ARCHITECTURAL REVIEW BOARD STAFF REPORT

Project #/Name	ARB-2024-58: 2415 Ivy Road (Bellair Place) Comprehensive Sign Plan Amendment
Review Type	Comprehensive Sign Review
Parcel Identification	06000-00-00-025A0
Location	2415 Ivy Road near the intersection of Canterbury Road (Figure 1)
Zoned	Commercial (C1) / Entrance Corridor (EC) / Airport Impact Area (AIA) / Steep Slopes - Managed
Owner/Applicant	JPA Tower Investors, LLC / Talley Sign Company (Keith Wagner)
Magisterial District	Samuel Miller
Proposal	To modify the Comprehensive Sign Plan (CSP) by removing one approved sign location, adding two new sign types and locations, and adding one letter color to accommodate signs for tenant spaces on the east side of the building.
Context	2415 Ivy Road is part of a small group of buildings (including 2405, 2409, and 2411) originally constructed as a John Deere dealership. The current signage for this building uses a limited color palette and a single illumination type to achieve compatibility.

Figure 4: Existing Approved Sign Criteria.

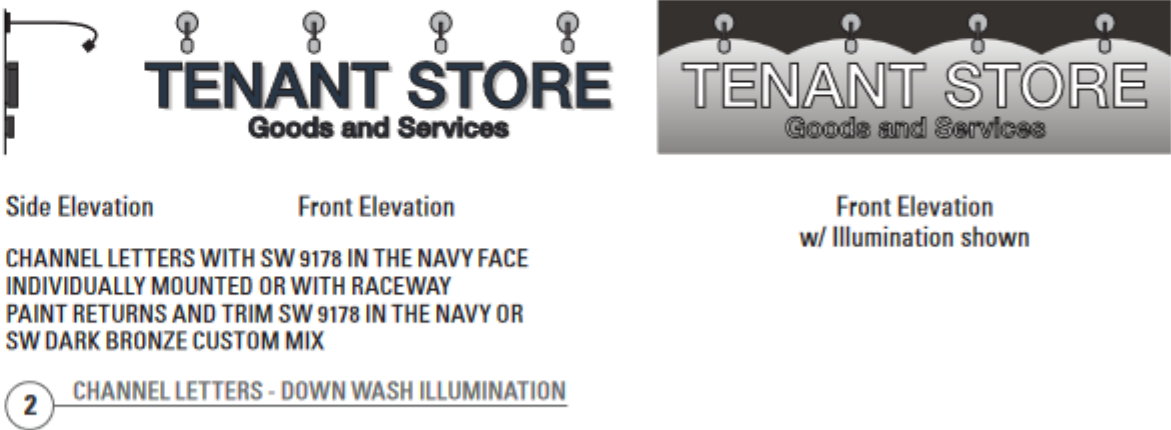
2, 4 8	Freestanding Signs	No changes are proposed to the approved criteria for the monument sign.	None.
4, 9	Wall Signs		
4a	Placement: The design of a building’s walls, window locations, parapets and other architectural features shall influence the Board’s evaluation of appropriate signage. Wall signs can help establish rhythm, scale and proportion across the façade of a building.	The proposed amendments to the sign plan are limited to the east elevation. The changes involve removing the approved sign area to the right of the bay door (Fig. 5) and adding two new sign locations: one below the canopy in front of the bay door and the other at the northeast corner of the building. The placement of the new sign locations does not obscure any of the detailing present along the elevation, but the projecting sign extends above the adjacent roofline. In this zoning district, projecting signs are not allowed to exceed the top of the fascia. Along the east elevation, there are additional locations under the canopy that could accommodate hanging signs. Revising the sign plan to show sign locations in	Revise the height of the projecting sign for Selvedge Brewing so it does not exceed the top of the fascia. Revise the CSP to allow hanging signs centered in the three canopy bays on the east elevation.

- 1. Revise the Selvedge Brewing projecting sign so that the maximum height does not exceed the top of the fascia.
- 2. Revise the sign proposal to clarify the lower mounting location for the Selvedge Brewing projecting sign.

- 1. Revise the CSP to allow hanging signs centered in the three canopy bays on the east elevation.
- 2. Add the following note to the sign plan: The ARB may require future tenants to modify the color and scale of standard templates for trademarks, service marks, corporate logos and graphics. When used, trademarks, service marks, corporate logos and/or graphics should be incorporated as an integral part of the overall sign.
